| Project | IEEE 802.16 Broadband Wireless Access Working Group < http://ieee802.org/16 > | |
| Title | Comments on MS Initial Ranging with Non-transparent RS (Centralized) | |
| Abstract | This contribution proposes modifications for MS Initial Ranging with Non-transparent RS | |

Table 199b—Ranging and automatic adjustments procedure in MR mode

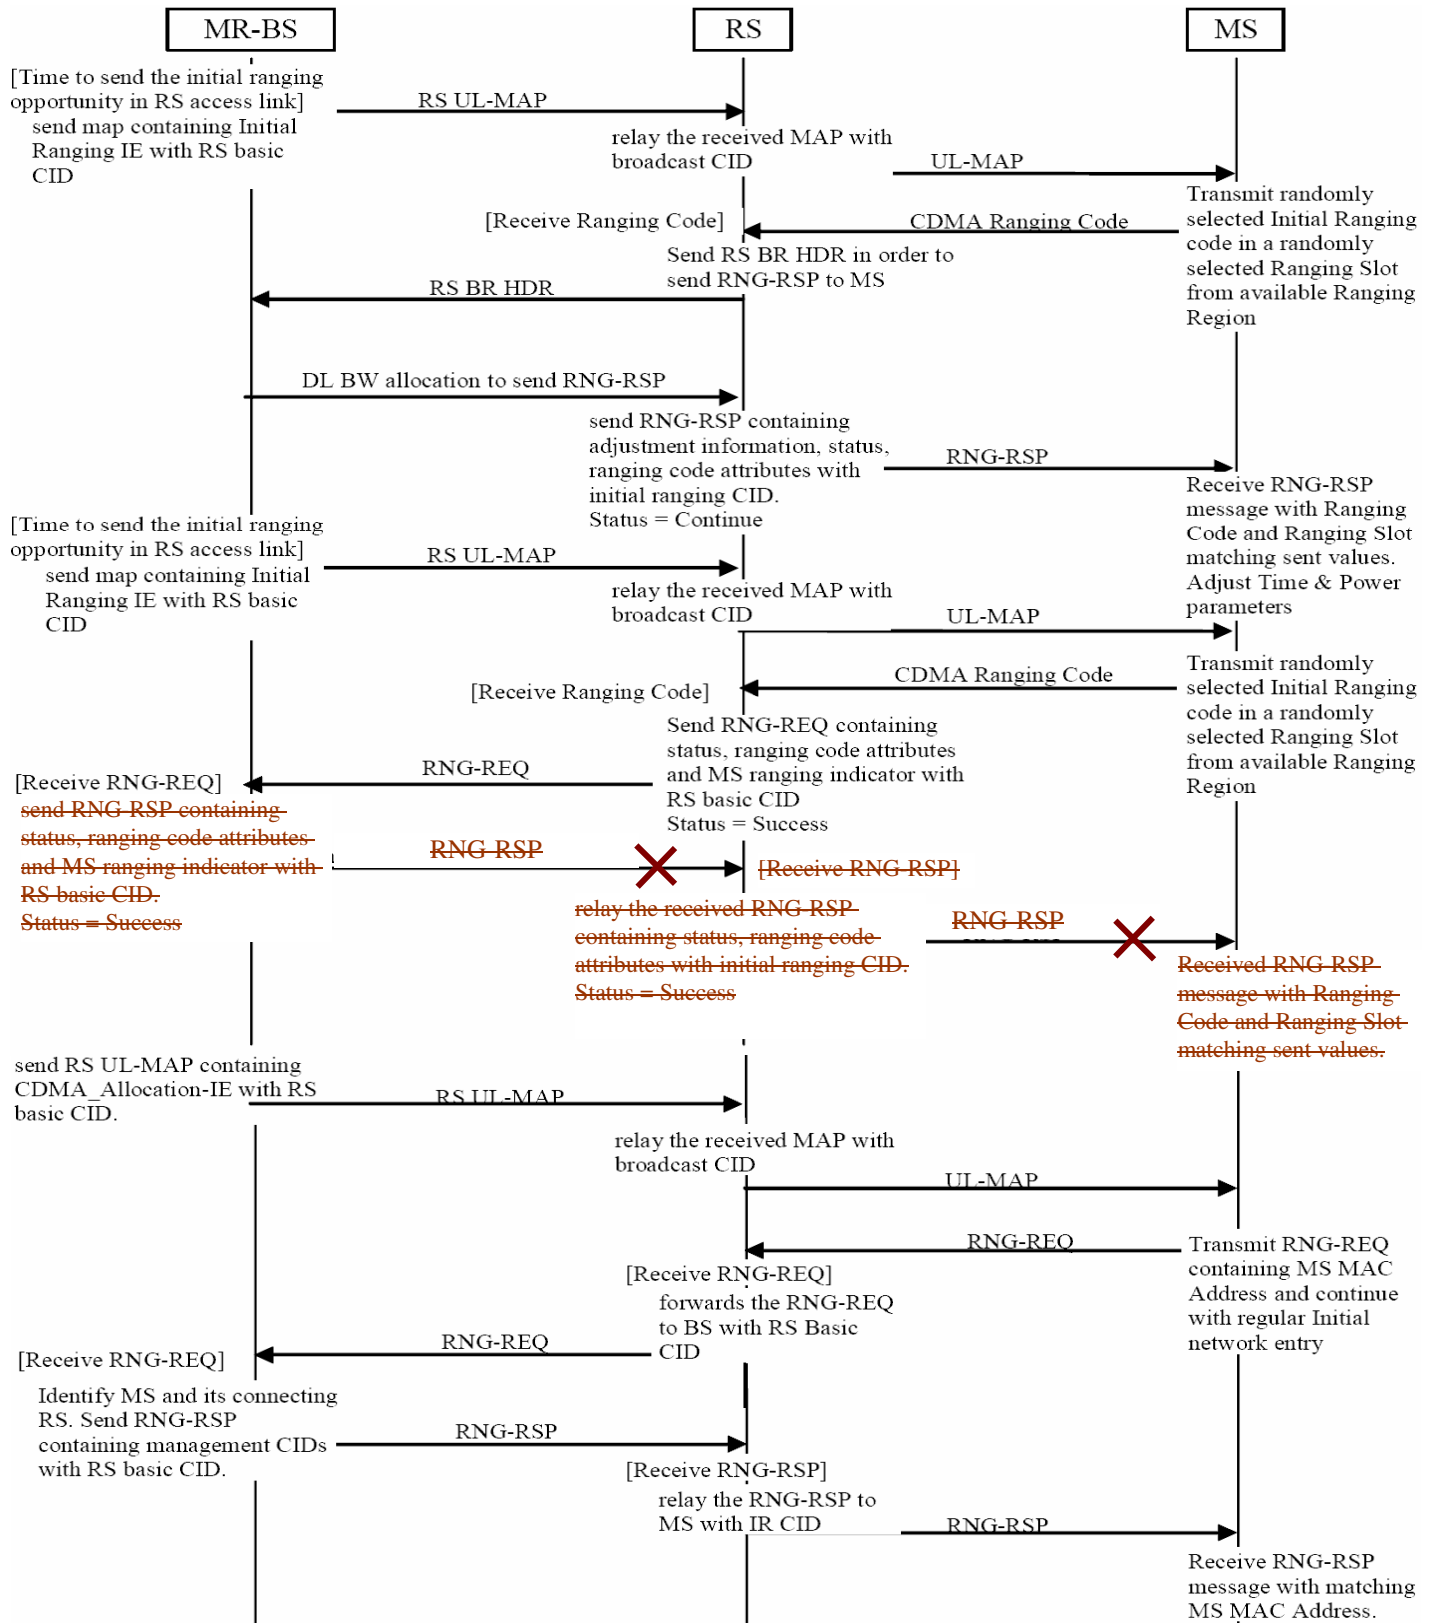
[Change the following Table 199b in page 84 as indicated]

Figure 95e Handle CDMA Initial Ranging Code at Non-transparent RS

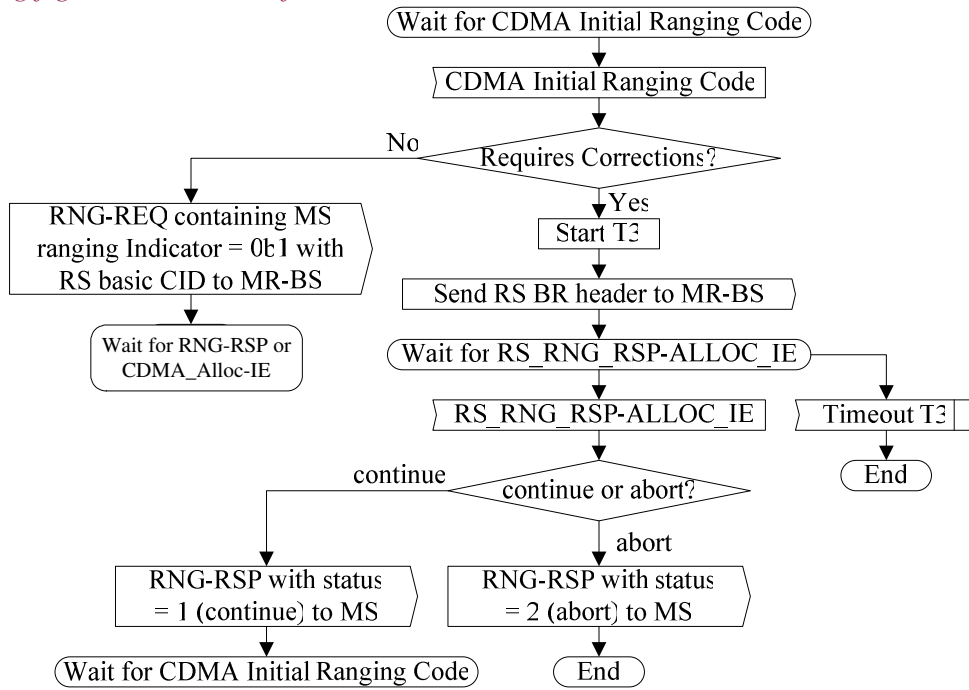
[Insert the following figures at the end of subclause 6.3.9.16.2.1:]
